TECHNICAL SERVICE BULLETIN

2021-2022 Bronco - Whistle Noise From Left Exterior Mirror

22-2297

Ford 2021-2022 Bronco

Figure 1 - Left side shown, right side similar

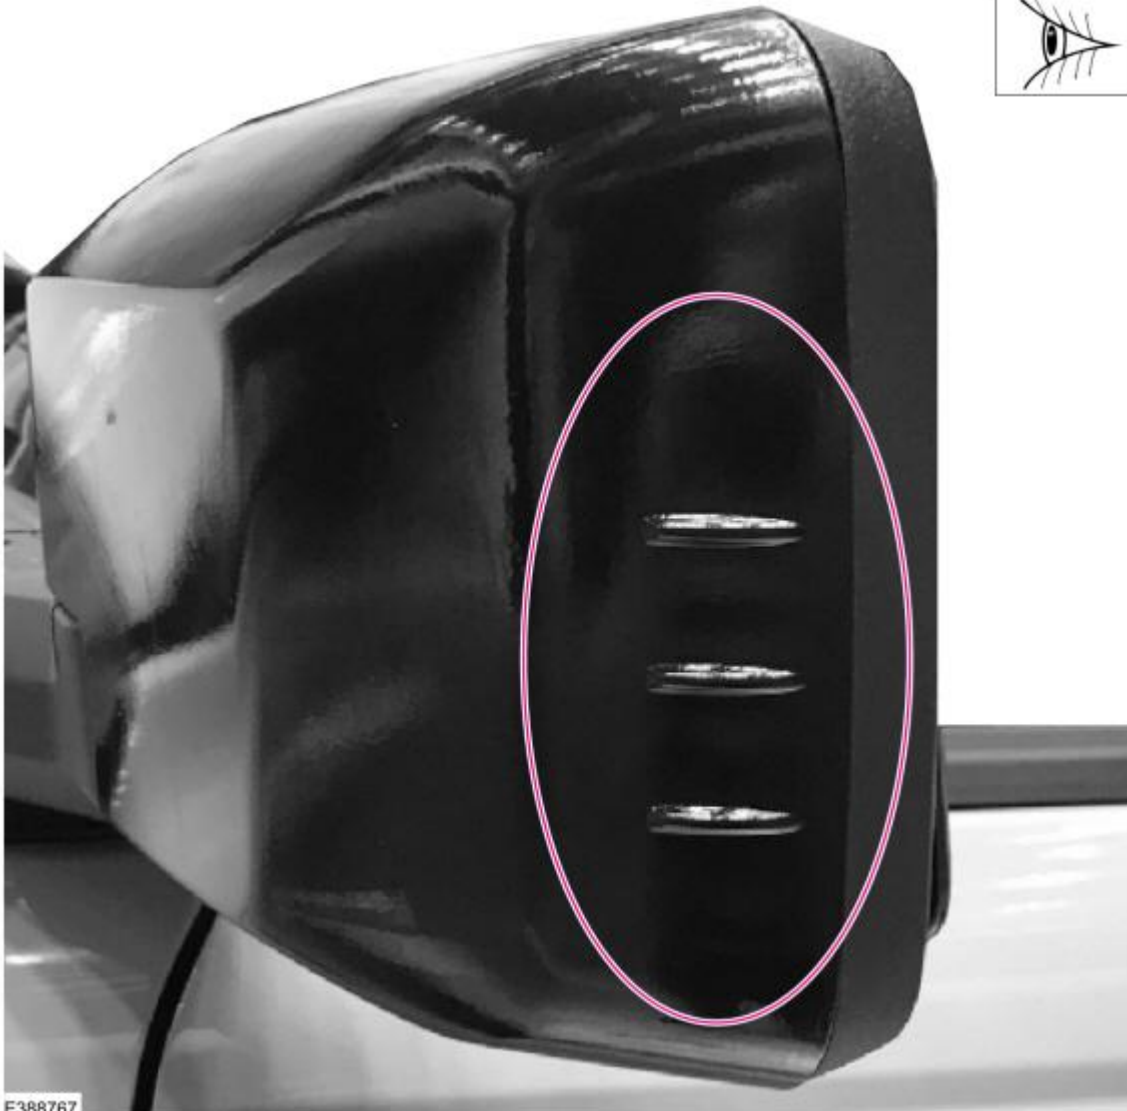
Issue: Some 2021-2022 Bronco vehicles equipped with base exterior mirrors (does not have integrated puddle lamps and/or turn signal lamps) may have a whistle noise that originates from the left exterior mirror. This may be due to the design of the exterior mirror cover. To correct this condition, follow the Service Procedure to replace both the left and right exterior mirror covers.

1. Does the left exterior mirror have 3 horizontal fins on the outboard side of the mirror cover? (Figure 1)

- (1). Yes - this article does not apply. Refer to Workshop Manual (WSM), Section 100-04 and continue with normal diagnostics.
- (2). No - replace both the left and right exterior mirror covers. Refer to WSM, Section 501-09. Both the left and right exterior mirror covers must be replaced to maintain a consistent vehicle appearance.
